Subject: UniStar Nuclear Energy, NRC Docket No. 52-016
Response to Request for Additional Information for the
Calvert Cliffs Nuclear Power Plant, Unit 3,
RAI No. 58, Seismic Design Parameters, Questions 03.07.01-3 and 03.07.01-5

**Response to NRC Request for Additional Information,
Seismic Design Parameters, Questions 03.07.01-3 and 03.07.01-5,
Calvert Cliffs Nuclear Power Plant, Unit 3**

Figure 1. Randomized Shear-Modulus and Damping Degradation Curves for Terrace Sand Material Used for Assumed Structural Backfill.

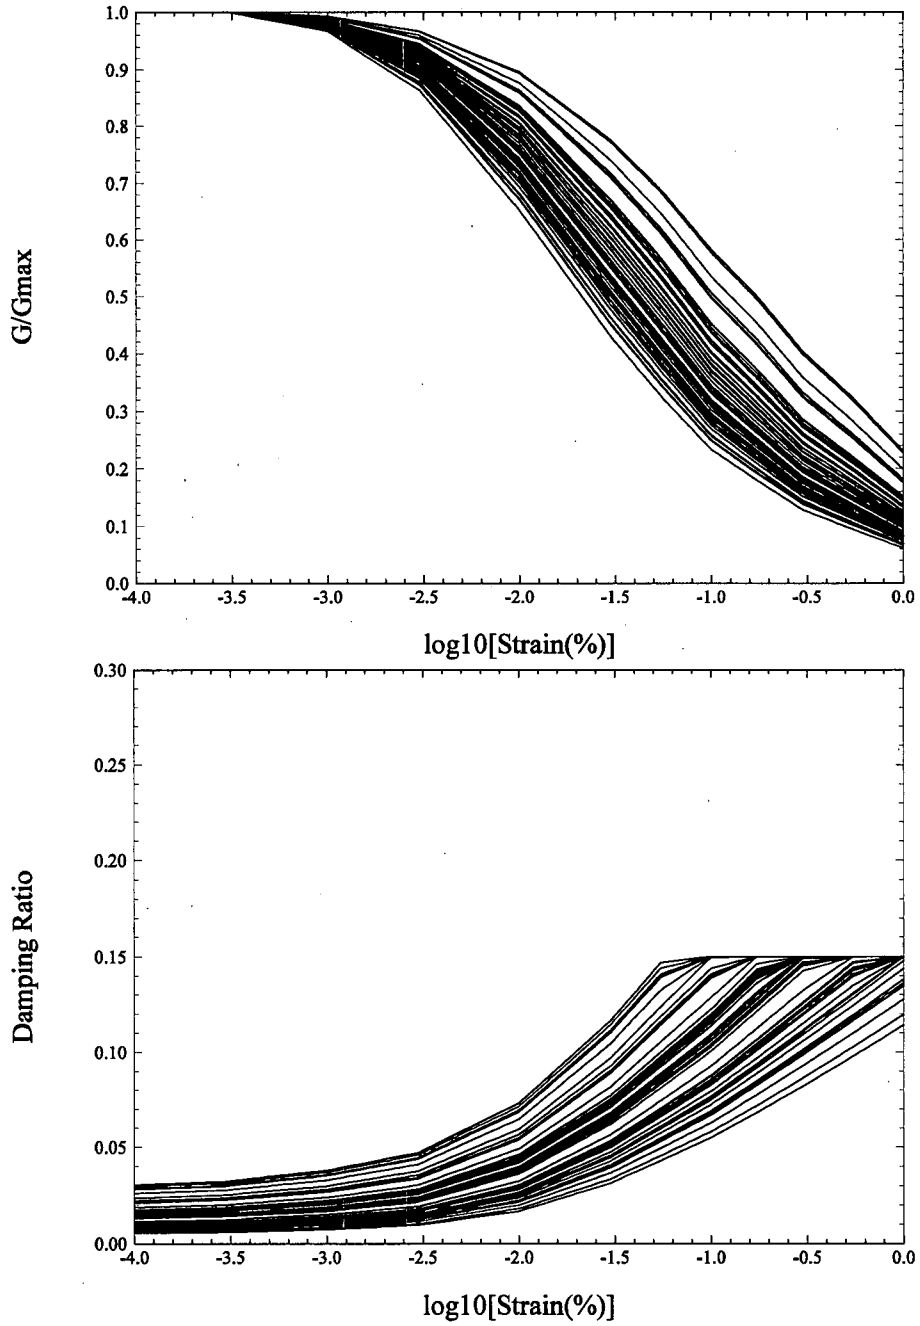
- How were the FIRS at grade elevation computed from the GMRS which were determined at an elevation 12.5 m (41 ft) below grade? Include in the response, computer codes, soil column model, and the basis for the shear wave velocity of the structural backfill that supports both the EPGB and ESWB and the impact of this backfill on the development of the FIRS?

Soil profile provided in FSAR Tables 2.5-51 and 2.5-53 is used for depths greater than 41 ft. The structural backfill properties considered in the analysis for the top 41 ft are provided in Table 1. The shear-wave velocity used for the top 41 ft of backfill corresponds to the in-situ soils (25 ft of Terrace Sands above 16 ft of Chesapeake clay/silt). Due to unavailability of the actual backfill properties, these values were considered representative of the structural backfill material at the time of writing the FSAR. Similarly, the unit weight and degradation curves for the Terrace sands were also considered representative of the backfill properties (see FSAR Table 2.5-53 and Figure 1 below). The dynamic properties for the in-situ soils are based on Resonant Column Torsional Shear (RCTS) Tests and are randomized as shown in Figure 1.

Figure 4: Calvert Cliffs Site SSE 5% damping spectrum (horizontal and vertical)

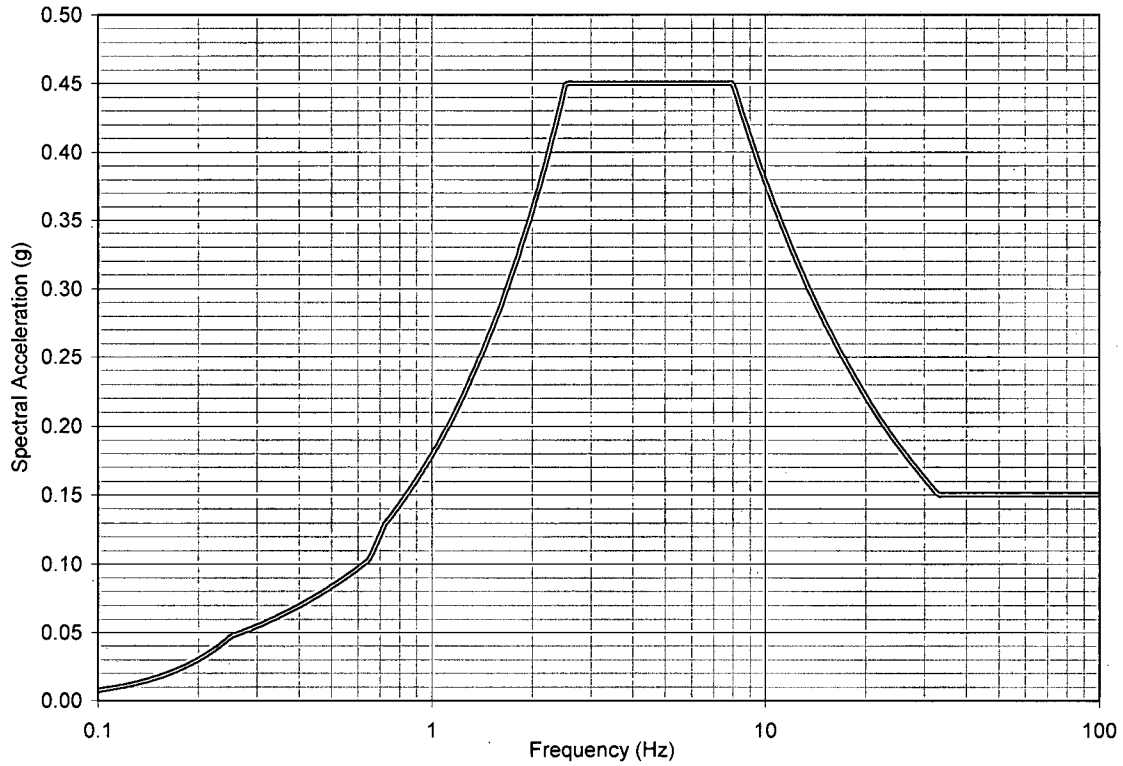
In FSAR Section 3.7.1.1.1 on page 3.0-33, it states that the design response spectra for the Ultimate Heat Sink Electrical Building (UHS EB) is conservatively established by an envelope of half the magnitude of the EUR soft soil spectrum with a zero period acceleration (ZPA) of 0.15 g and the In-Structure Response Spectra (ISRS) developed at the operating deck of the UHS makeup water intake structure (UHS MWIS). Since this is the seismic design input for this structure, provide and include in the FSAR the horizontal and vertical spectra depicting these design spectra envelopes. In addition, provide in the FSAR a reconciliation of the design response spectrum with the horizontal foundation input response spectra (FIRS) for this structure which meets the minimum requirements of 10 CFR Part 50, Appendix S. Also, include a description of how the FIRS are developed including the soil model, soil properties, backfill properties, computer programs and analysis assumptions.

Figure 4 depicts the one set of horizontal and vertical Calvert Cliffs Site SSE spectra, which replaces the two sets of spectrum described above and included in FSAR Section 3.7.1.1.1. This spectrum will be used for the SSI analysis of the UHS EB integrated with UHS MWIS and other structures in the vicinity. The development of this smooth broad band spectrum is discussed in the response to RAI 58 Q03.01.07-4¹. The results of the SSI reconciliation analysis and justification of Calvert Cliffs Site SSE spectrum as design spectra for UHS EB will be provided at a future date with responses to RAI No. 65 Questions 03.07.02-4 and 03.07.02-12 according to the schedule provided in Enclosure 1.
